UNITED STATES PATENT AND TRADEMARK OFFICE

Office Action Summary

10/538,176

YAMA ET AL.

Prior Art
Fig. 2A
US 6,039,042

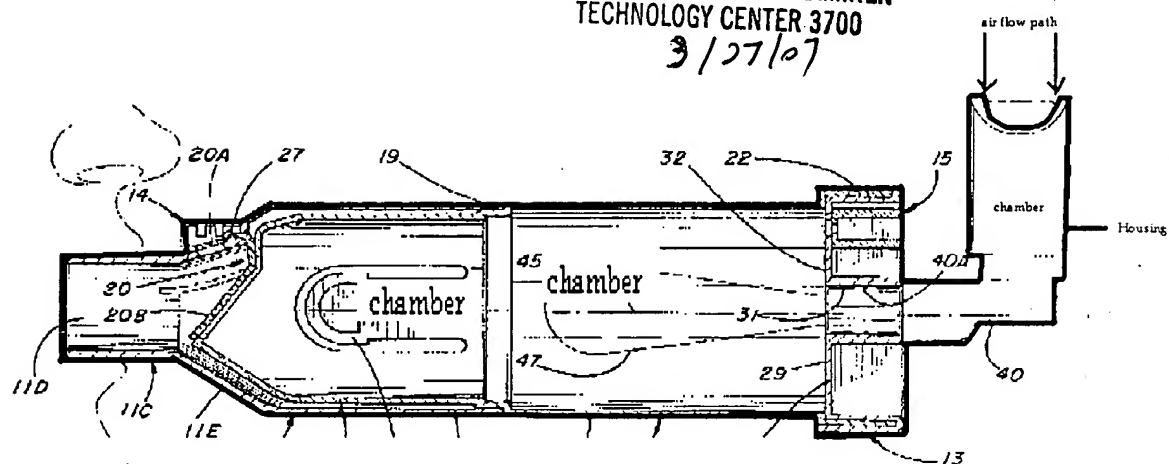
As to claim 1, Sladek in figures 1-8 discloses an inhalation device for transpulmonary administration a chamber (space inside the apparatus depicted in fig.2A, see labeled fig.2A attached below) for containing a pharmaceutical composition which is pulverized into fine particles by an air-generated impact for dispersal in air; an air inlet flow path (see labeled fig.2A, attached below) for introducing to the chamber outside air to apply the air-generated impact to the pharmaceutical composition and for injecting the outside air toward the pharmaceutical composition; an inhalation flow path (31) having a suction port (a path through apertures formed by ribs 29, see fig.1) located inside the chamber to inhale the pulverized pharmaceutical composition; a housing (body of the apparatus depicted in fig.2A, see labeled fig.2A attached below) for accommodating the chamber, the air inlet flow path, and the inhalation flow path; a mouthpiece (11) provided at one end of the housing, the mouthpiece being provided with a mouth-side flow path (11D) which communicates with the inhalation flow path, and an auxiliary

flow path (20A) for directly inhaling the outside air which does not communicate with the inhalation flow path and the mouth-side flow path. Sladek, however, lacks explicit teachings of wherein the inhalation device for transpulmonary administration is configured such that the air-generated impact is applied to the pharmaceutical composition by the outside air which flows into the chamber by inhalation-induced pressure generated when a user (patient) inhales air, and the pulverized pharmaceutical composition is introduced to the mouth-side flow path, and at the same time the outside air is directly introduced to the auxiliary flow path by the inhalation-induced pressure. However, it should be noted that the “air-generated impact” and “pulverized pharmaceutical composition” are provided by the air flow port/paths as claimed, and such air flow port/paths are taught by Sladek, thus, Sladek’s device is inherently capable of providing air-generated impact and pulverization of the pharmaceutical composition. Therefore, it would have been obvious to one of ordinary skill in the art to consider the use of Sladek’s device would have provided the function of “air generated impact” and pulverization of the pharmaceutical composition because Sladek also teaches a housing large enough to provide a pulverization surface (see fig.2A) for the pharmaceutical to be impacted when the outside air is introduced into the housing by the inlet flow path, auxiliary flow path, and/or suction port prior to inhalation.
